September 4, 2015

TEC Ref. T0604

RE: Proposed Sub-Division – 73 Olive Street – Ashland, Massachusetts  
Traffic Peer Review Comments

Figure A-1

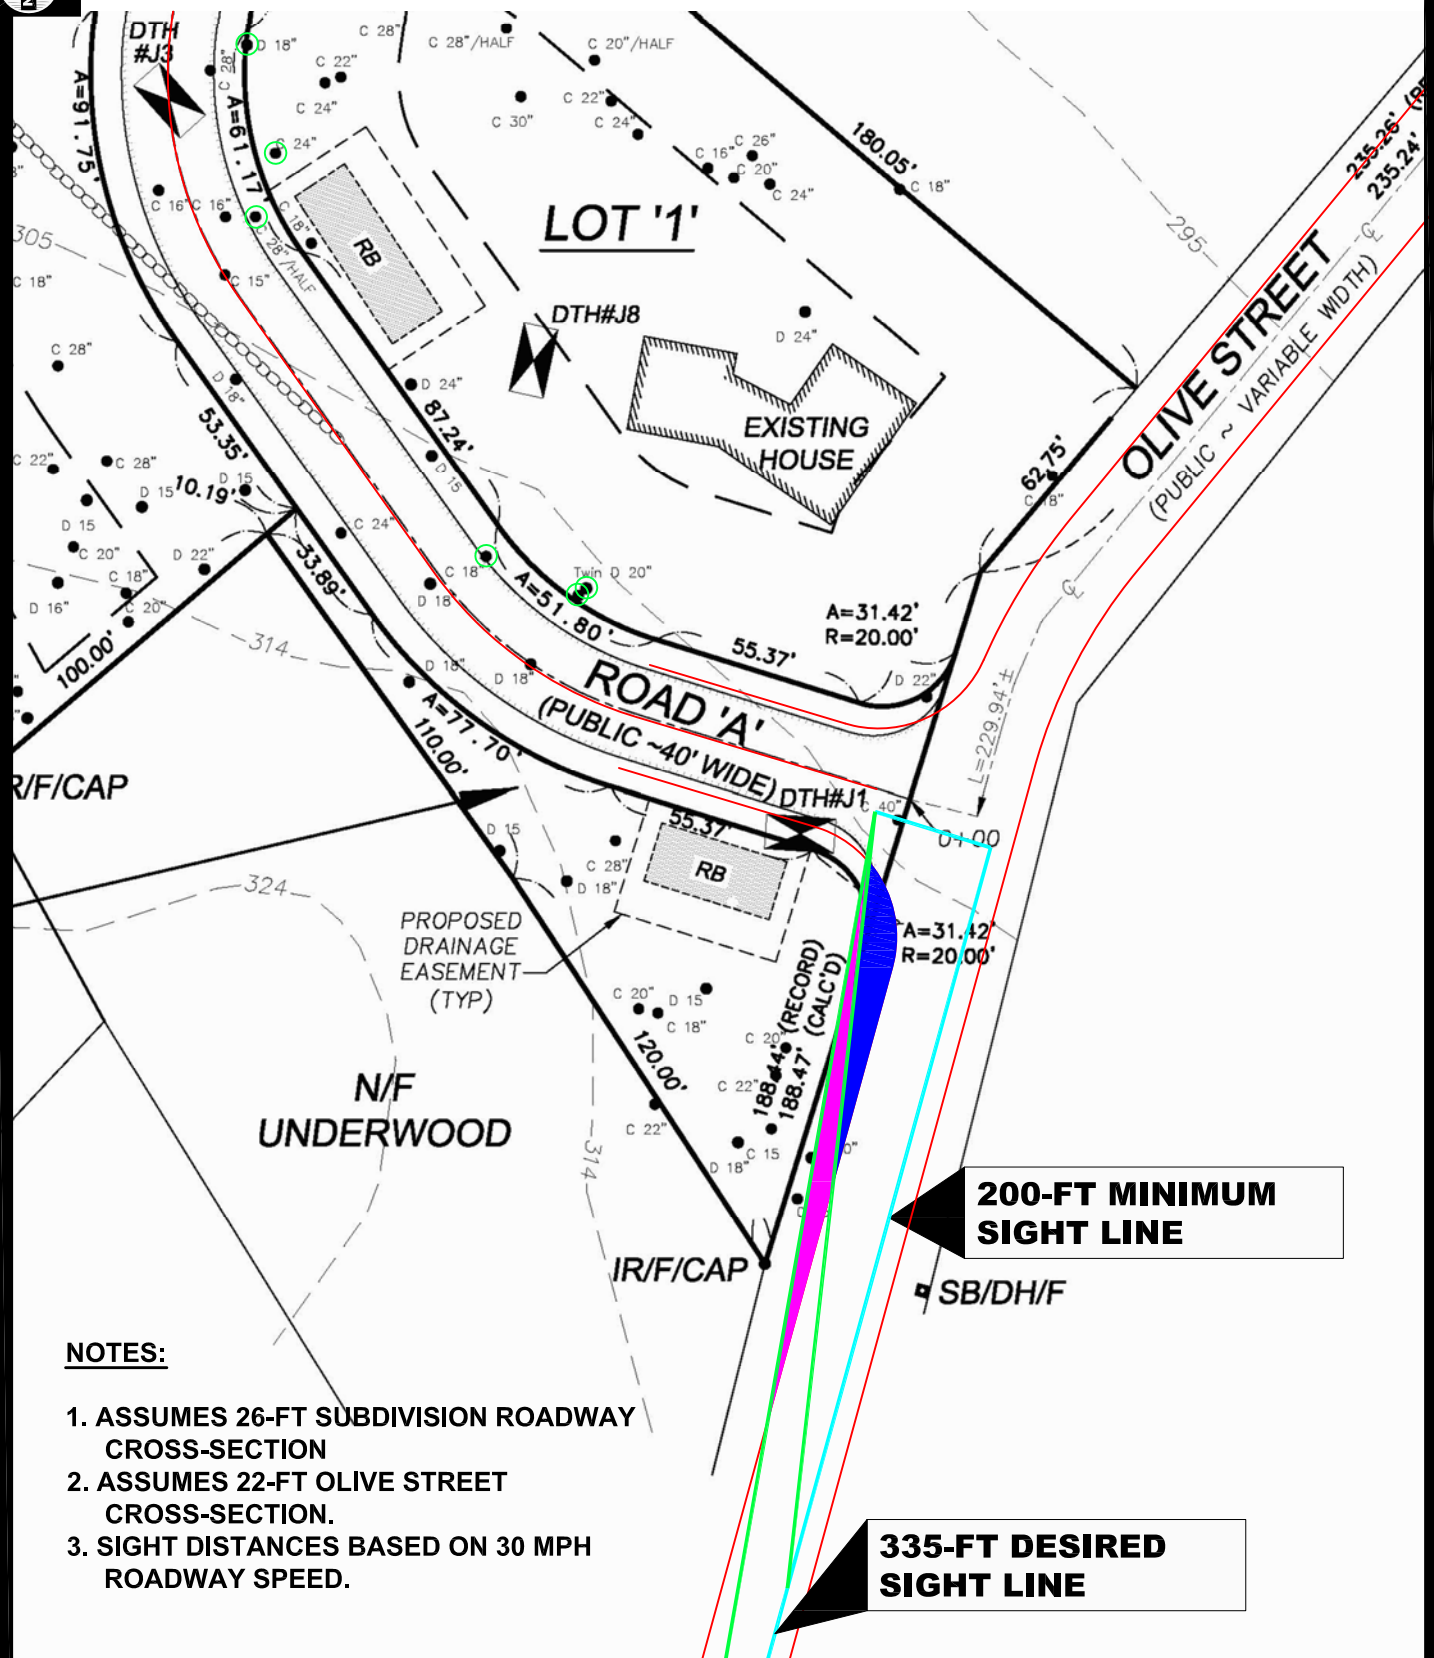
As shown in Table 1, sufficient SSD is provided along Olive Street in both the northbound and southbound directions. Although sufficient ISD is provided at the proposed subdivision roadway looking north, excessive vegetation currently blocks sight lines looking south from the proposed subdivision roadway. The Applicant should commit to clear vegetation adjacent to Olive Street, south of the proposed subdivision roadway to provide for sight lines that meet the AASHTO minimum for intersection sight distance (200 minimum, 335 feet desired). Figure A-1 depicts the area along the west side of Olive Street that should be cleared to provide sufficient sight lines at and approaching the proposed subdivision roadway.

- 10.) The Preliminary Plan depicts no off-site transportation mitigation program. TEC recommends that the Proponent commit to trimming and clearing vegetation within the right-of-way and on the proposed subdivision property along the westerly side of Olive Street, consistent with the clear zones shown in Figure A-1, to maximize sight distances. This clearing should be completed prior to issuance of a Certificate of Occupancy and should be regularly maintained to ensure sight lines continuously meet minimum requirements. No further mitigation is warranted based on the limited impacts of the project on traffic operations along the adjacent roadways.
